# UNITED STATES PATENT AND TRADEMARK OFFICE

APPLICATION NO.	FILING DATE	FIRST NAMED INVENTOR	ATTORNEY DOCKET NO.	CONFIRMATION NO.
10/679,552	10/06/2003	Jurgen Wafzig	ZAHFRI P549US	3295

**Office Action Summary**

### **DETAILED ACTION**

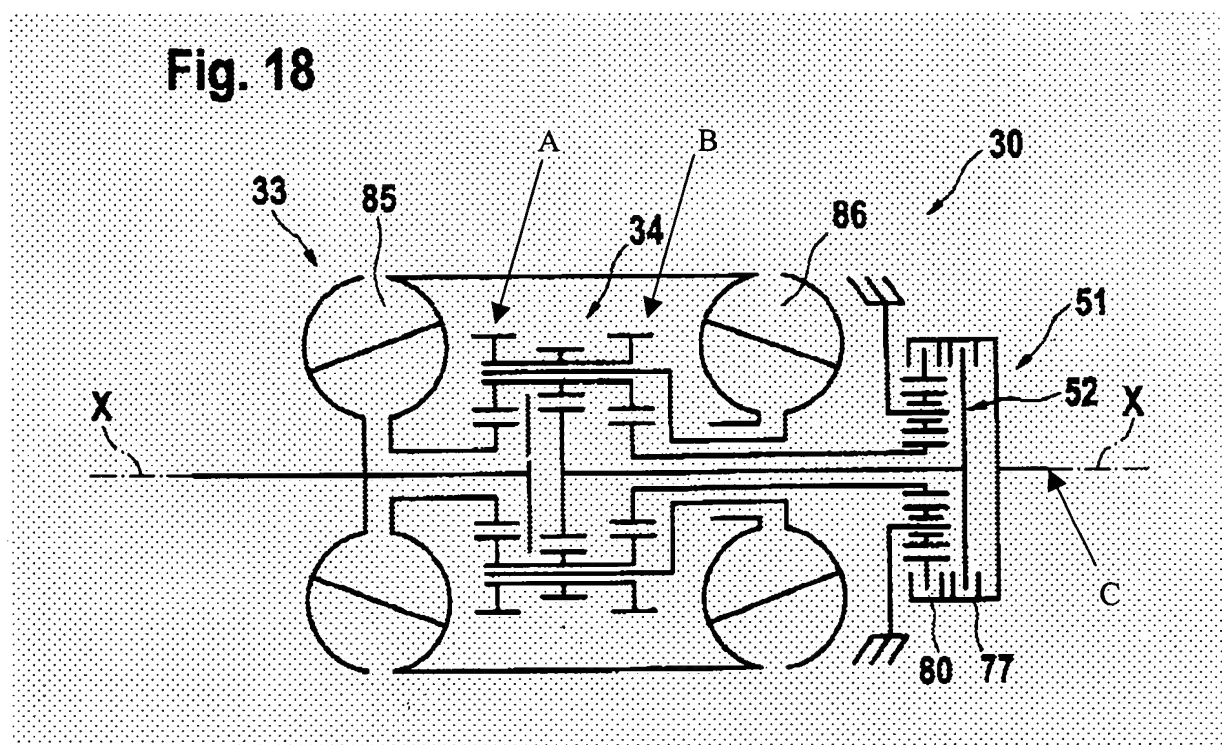
Geiberger et al teach a split performance power train (see Fig. 18) comprising:

a friction wheel variable speed transmission (33); and

a planetary gear set (34, 52) designed as a summation set of gears,

wherein a first planetary gear set (A) (see the Fig. below) and a third planetary gear set (B or 52) are planned, whereby the friction wheel variable speed transmission (33), the first planetary gear set (A), a second planetary gear set (52 or B) and the third planetary gear set (B or 52) are coaxial and arranged consecutively in the direction of the power flow.

Regarding claim 9, wherein the transmitted power in the friction wheel variable speed transmission (33) over the first planetary gear set (A) is transmitted coaxially through the friction wheel variable speed (33) to the second planetary gear set (52).

Regarding claim 10, wherein the third planetary gear set (52) is arranged at a side of an output (C).

Regarding claim 11, wherein the first planetary gear set (A) is arranged between paired disks of the friction wheel variable speed transmission (33).
